Fuel Cell System Cost for Transportation—2008 Cost Estimate

Independent Review

Independent Review Panel Summary Report

From: Independent Review Panel, Fuel Cell System Cost for Transportation – 2008 Cost Estimate
To: Dr. Michael A. Duffy, NREL, DOE Hydrogen Systems Integrator
Subject: Independent Review Panel Report

Figure 1. Argonne National Laboratory PEM system model used by TIAX for the cost analysis

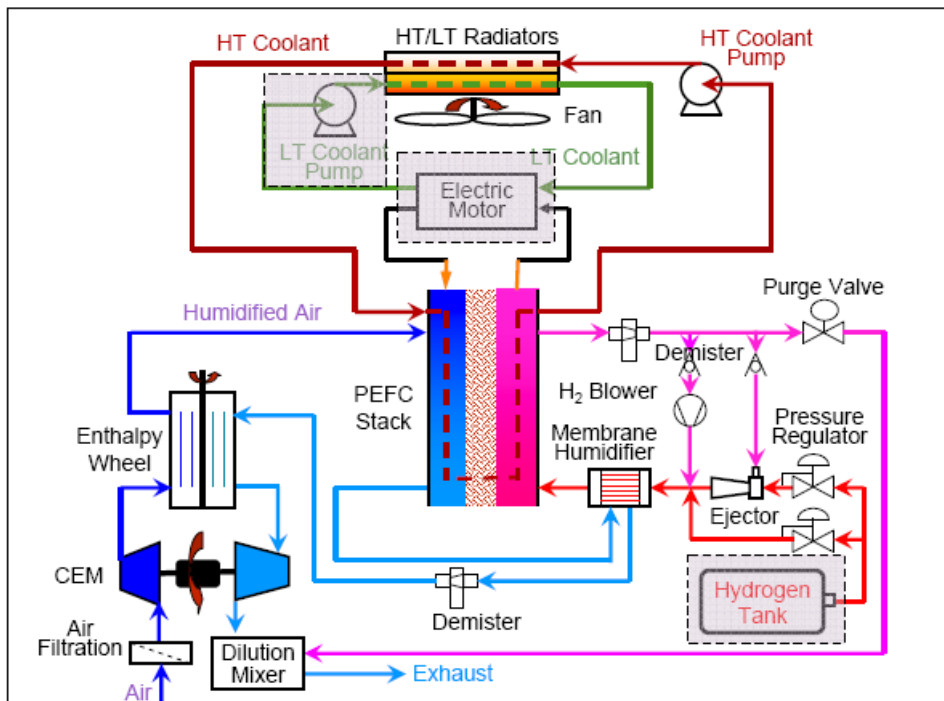
The fuel management subsystem has a hydrogen blower as a major component and two ejectors (see Figure 1). TIAX estimated the cost of the hydrogen recirculation blower based on published information and patents on the Parker Hannifin Model 55 Univane™ rotary compressor. TIAX used the DFMA software to apply its bottom-up approach. The projected cost of the hydrogen recirculation blower is \$193 per unit at a production rate of 500,000 units per year.

The water management subsystem identified by TIAX is not considered representative of today's technology or future PEM technology by the industry experts and the Panel. The major components of the water management subsystem are the EWH and the membrane hydrogen humidifier (MH). The major technical issue is with the EWH; based on industry interviews and FCTT, no fuel cell OEM uses the EWH to humidify the air. The EWH is introduced to the system via the ANL model and has the advantage that the air exiting the CEM (see Figure 1) does not need to be cooled before it enters the EWH.

Figure 2. Flow schematic of the 80-kW_{net} direct hydrogen PEM system model used by DTI for the cost analysis

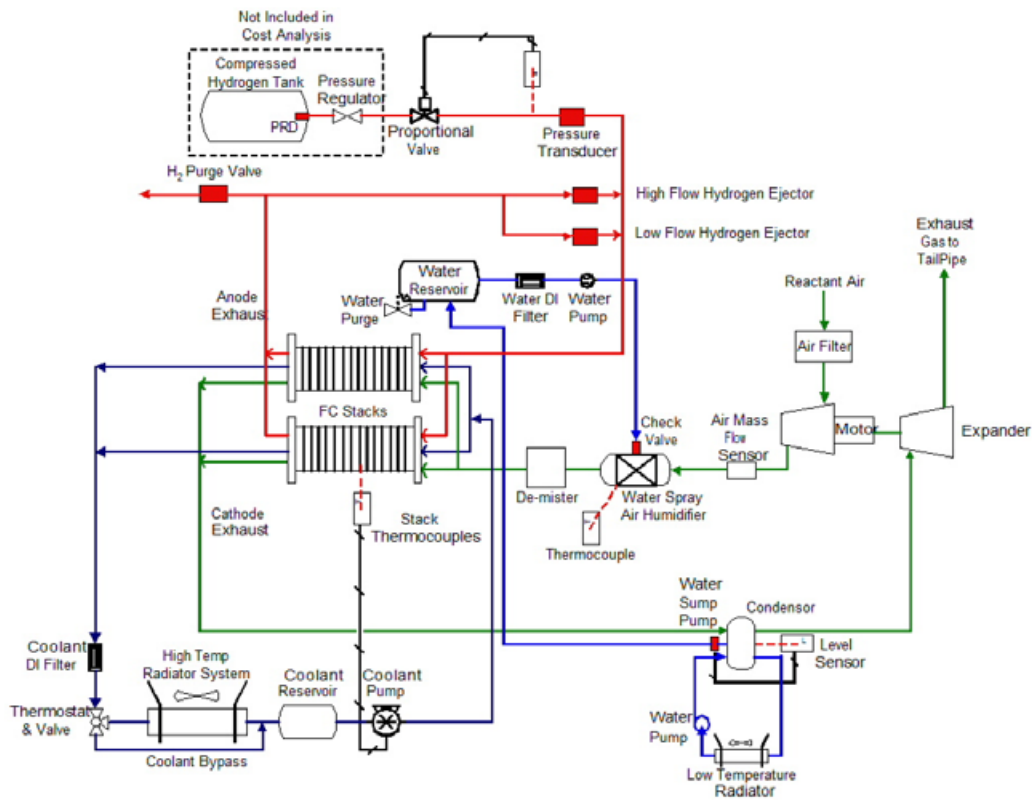
The overall system design (see Figure 2) was based on DTI's best approximation of the state-of-the-art technologies and how these might be assembled to achieve a functional unit. DTI used no proprietary information on system design in its system. As a result, it does not represent any system currently in use or under evaluation by OEMs or their respective suppliers.

- A thermodynamically correct system configuration by DTI would improve its ability to select and size components, which would influence the overall cost analysis.

Figure 4. Ionomer cost projection

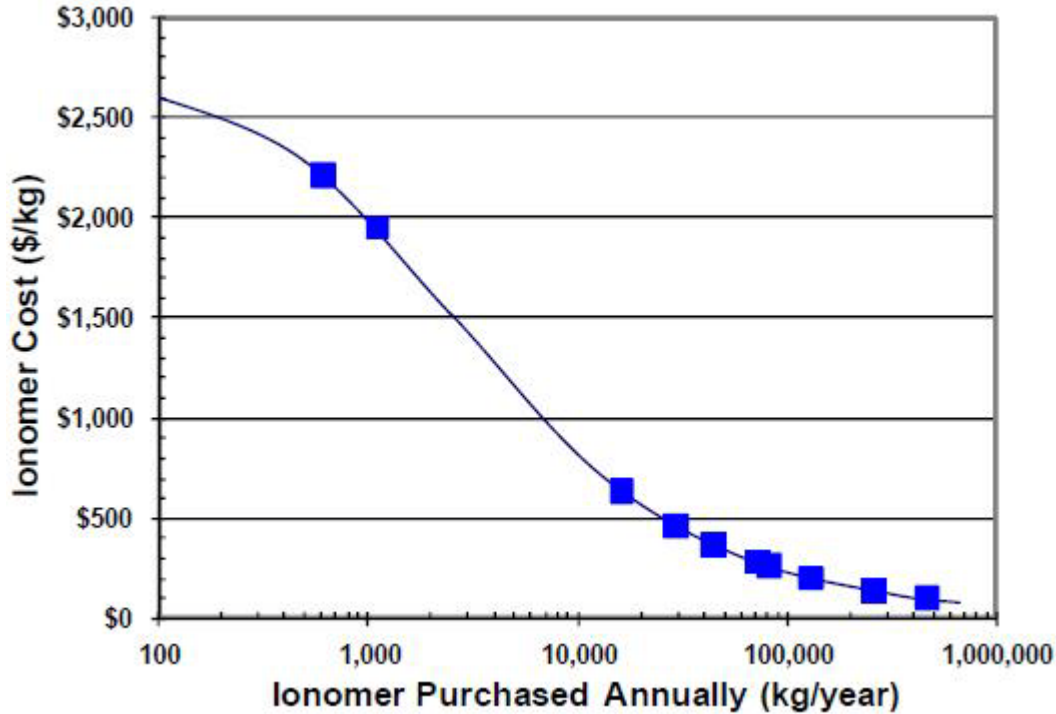
If DTI's curve of ionomer cost reduction as a function of volume is correct (see Figure 4)¹⁴ and if each supplier has about 50 tonnes/year of sales, the ionomer cost will be about \$400/kg. If the cost of manufacturing the membrane does not change, this analysis (if correct) would increase the membrane cost to approximately \$60/m² at 500,000 stacks/year. This is a significant difference from the \$16.62/m² estimated by DTI, which assumes that all membrane is produced by a single supplier.

Figure 5. Roll processing process for depositing catalyst layers formed with edge seals using the decal transfer method; from 3M patent U.S. 7,195,690

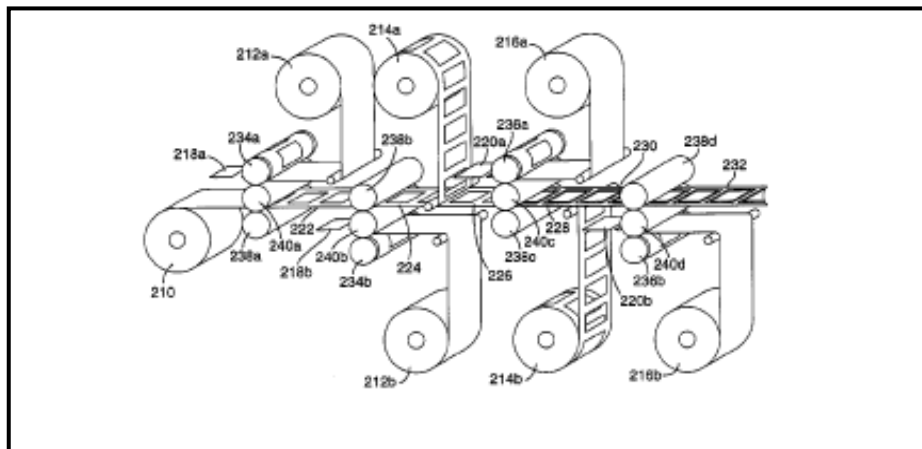
The continuous roll application of the catalyst layers will require a finite bonding period to hot bond the catalyst layer to the membrane that defines the production rate for the MEAs. TIAX did not identify the bonding period. Assuming 60 seconds as the rate controlling stage (two thirds of the hot pressing period²⁰) for the hot bonding process and using the manufacturing criteria from the TIAX report,²¹ 400 roll processing systems would be needed to meet the 500,000 systems per year production automotive requirements. Industry interviews identified that several production lines will be needed to reach constant state of manufacturing. The reproducibility of the 400 MEA manufacturing systems would need to be very high to meet the TIAX assumption of 100% yield.

TIAX did not discuss fabricating multiple MEAs with a wide membrane, forming a continuous, edge-to-edge coating of catalyst, and subsequently applying wide GDLs before slitting the wide MEA into rolls ready for die cutting. The concept of an edge-to-edge coated membrane may have technical difficulties with corrosion and shorting of the catalyst layers. Although the wide membrane with edge-to-edge catalyst coating may provide the highest production rate, the durability will need to be demonstrated.
